**R66 SERVICE BULLETIN SB-17A**

**SUBJECT:** F642-1 Shaft Replacement

**ROTORCRAFT AFFECTED:** R66 Helicopters equipped with F642-1 revision C and prior shaft weldments (originally installed on R66 S/N 0001 thru 0172), as well as spare F642-1 revision C and prior shaft weldments.

**FIGURE 1**

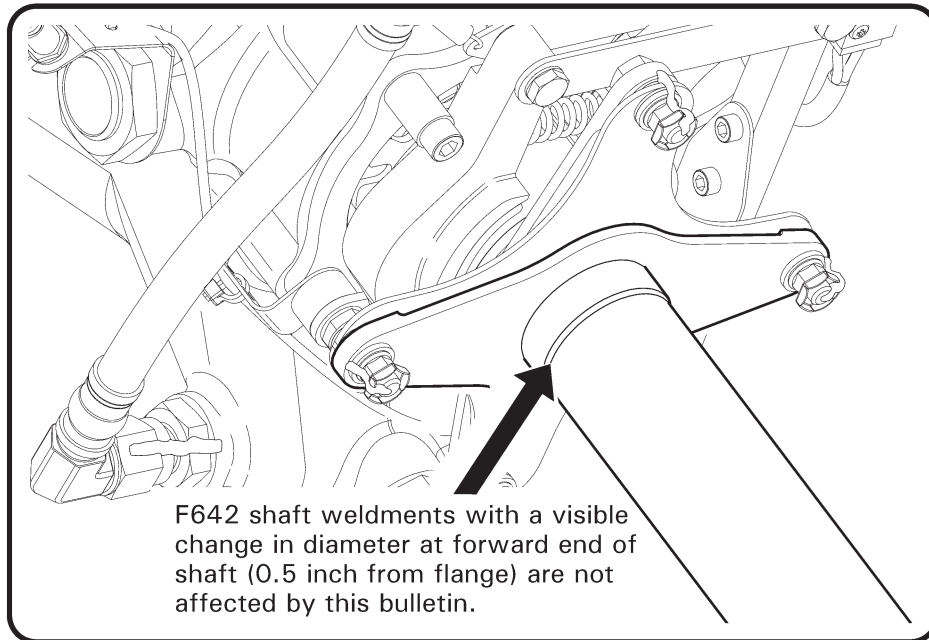
1. Refer to Figure 1. Visually inspect forward end of installed F642 shaft weldment for a visible change in diameter. Shafts with a change in diameter at location shown are revision D or subsequent and therefore are not affected by this bulletin; no further action is required.
2. If installed shaft does not have a change in diameter at location shown, remove shaft per R66 Maintenance Manual (MM) § 63-10, order one R9535 kit from [RHC Customer Service](#), and install kit per MM § 63-10. (For kits which contain F642-7 shaft, use NAS6604-5 bolts to attach shaft to flex plates.)
3. Balance shaft per MM § 18-70 in conjunction with chart in Figure 2.
4. Make appropriate maintenance record entries. No change to helicopter weight and balance.

**FIGURE 2**

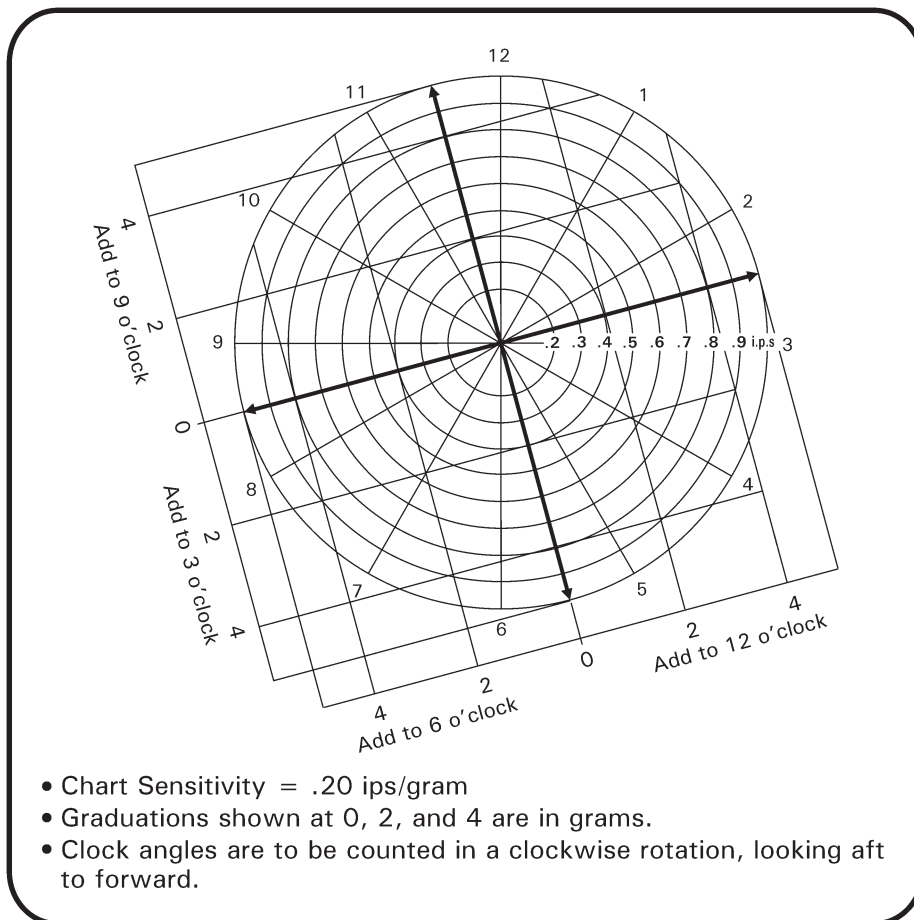
**R9535 kits with F642-7 shafts include:** (8) B330-13 palnut, (8) D210-4 nut, (1) F642-7 shaft weldment, (16) NAS1149F0432P washer, (8) NAS1149F0463P washer, (4) NAS6604-5 bolt, & (4) NAS6604-6 bolt.
